Project Name: 9101 Highland

Description: Revised special land use approval and final site plan approval

RE: 9101 Highland Road-Proposed Commercial Development- Final Site Plan/Final Engineering Plan Review – 3rd Review

Final Site Plan / Special Land Use Review for White Lake Charter Township, Michigan

3 TYPICAL DUMPSTER SCREEN WALL DETAIL
A-302 A-302 SCALE: 3/4" = 1'-0"

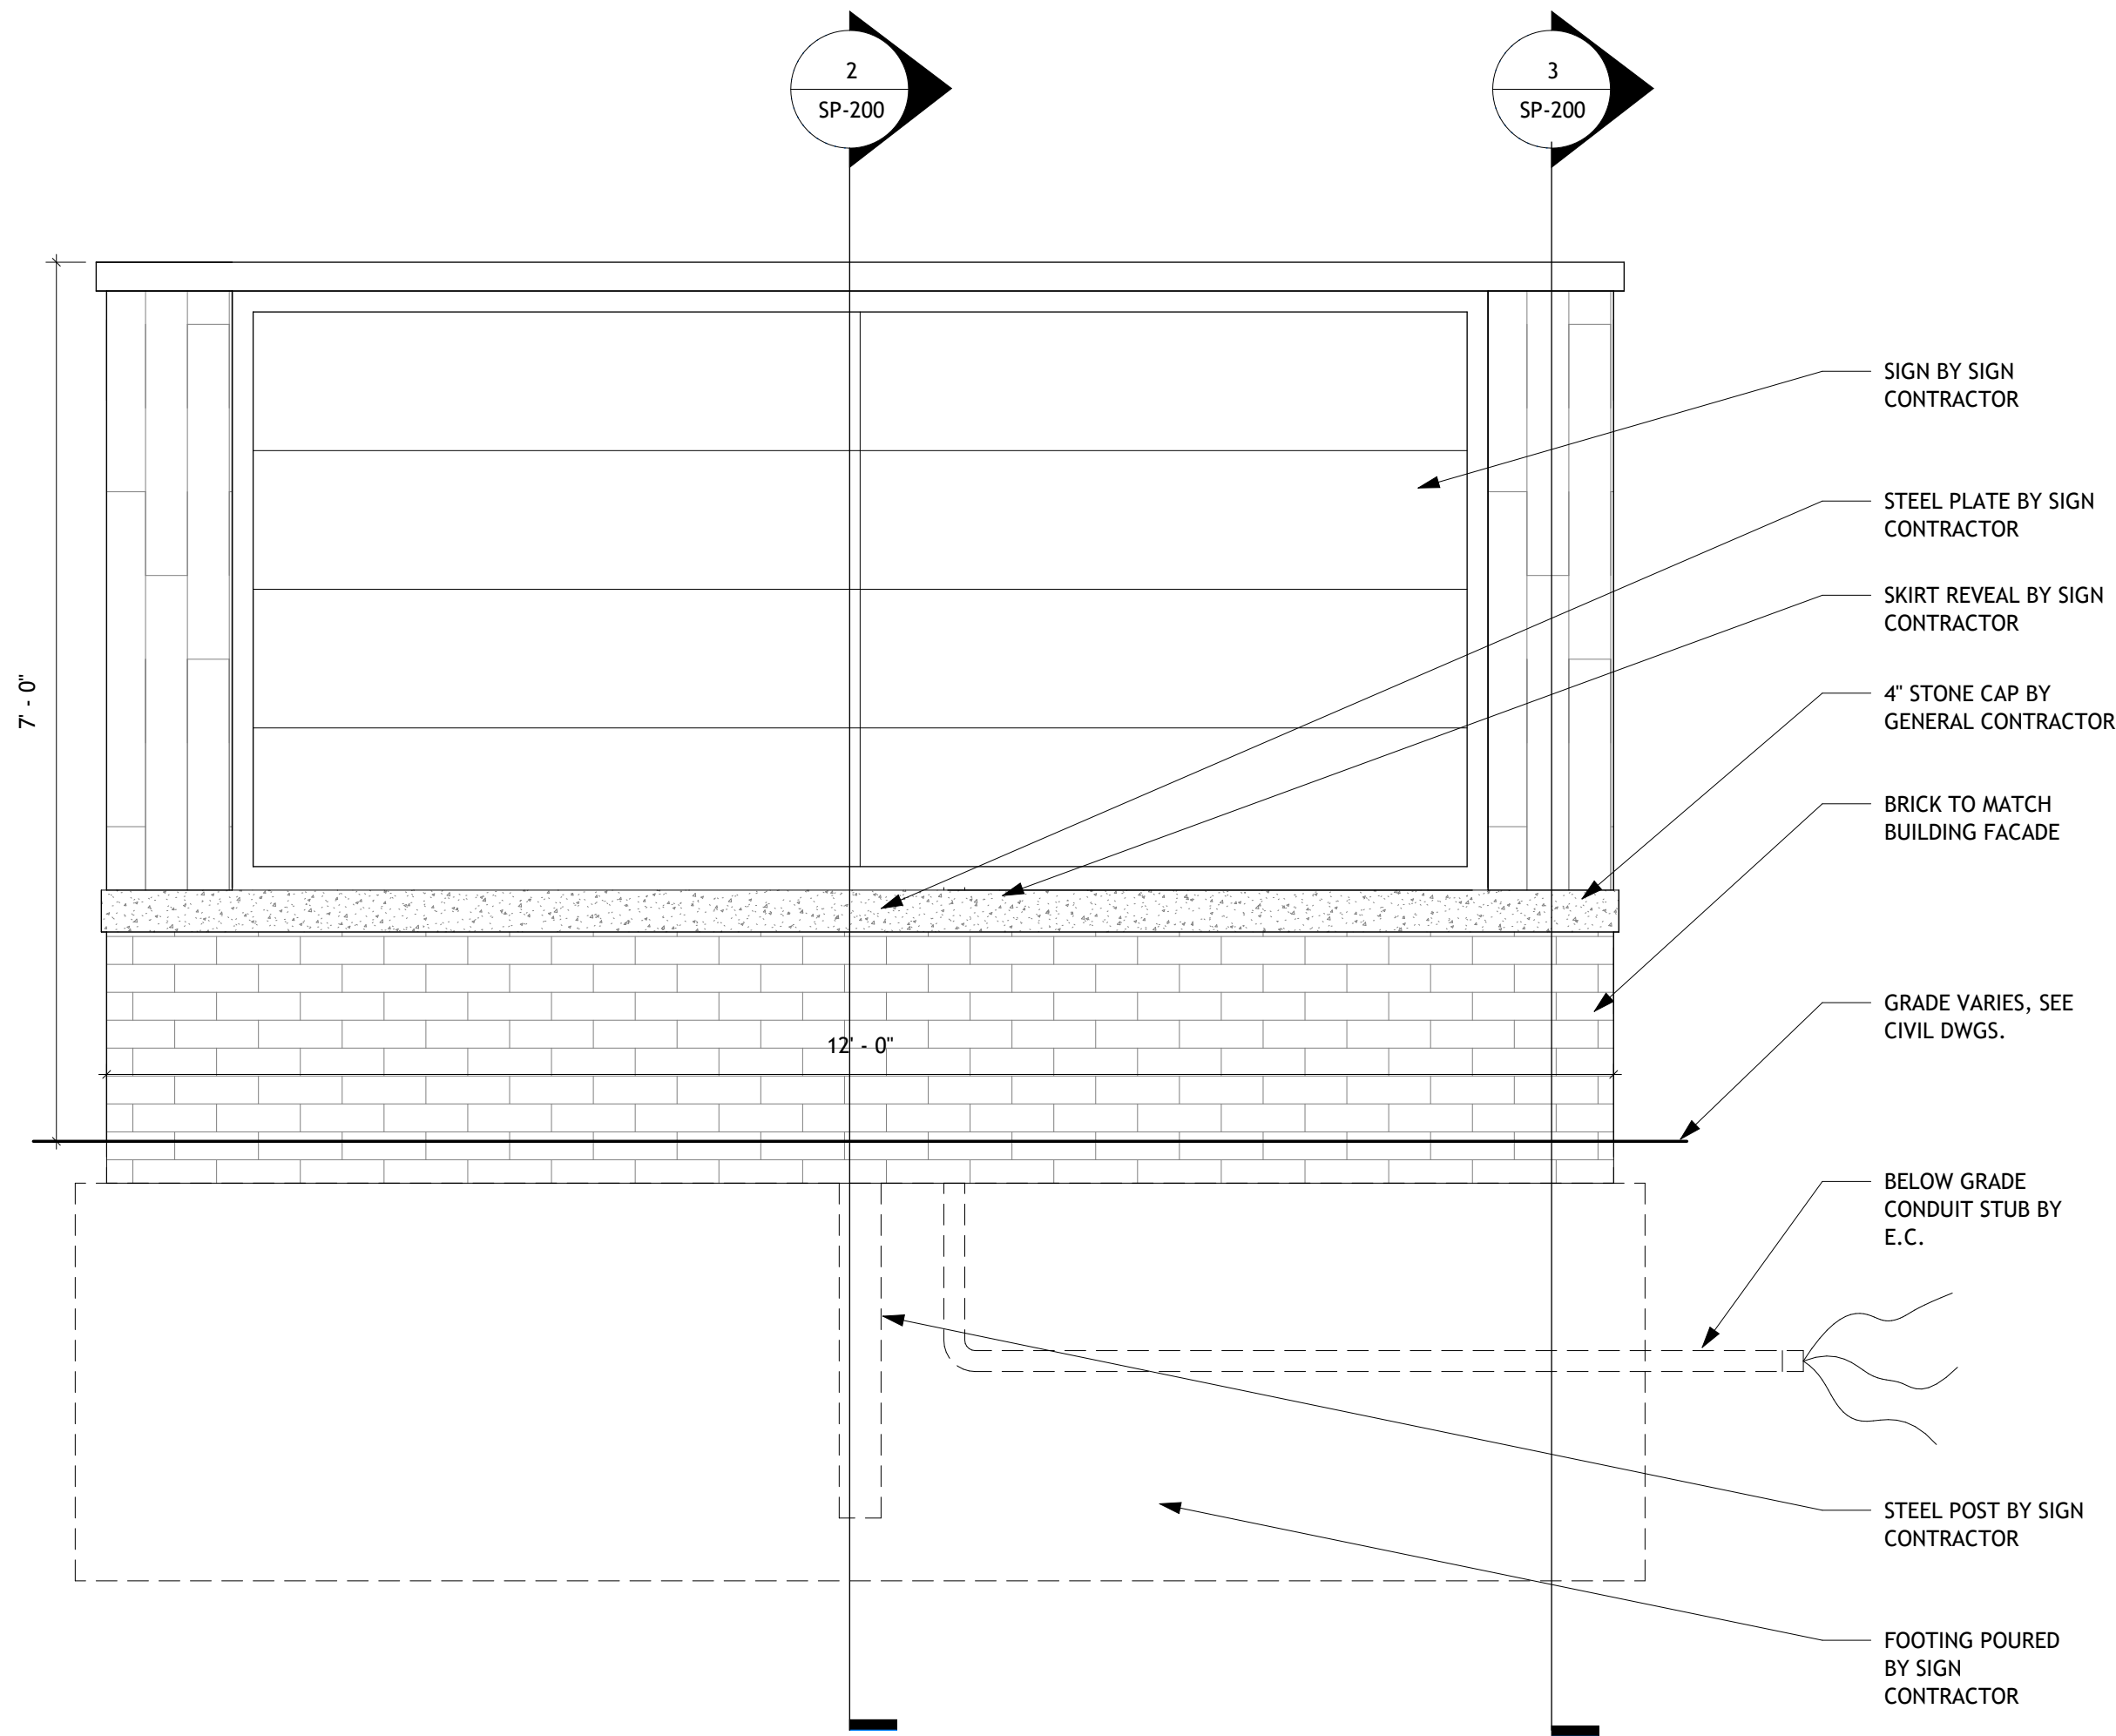
concrete or stained, decorative CMU block may be permitted where the principal building is not masonry, however, plain CMU block is not allowed. Sheet A-302 provides enclosure details that reference enclosure walls as CMU with brick veneer and wood stained gates with a metal frame.
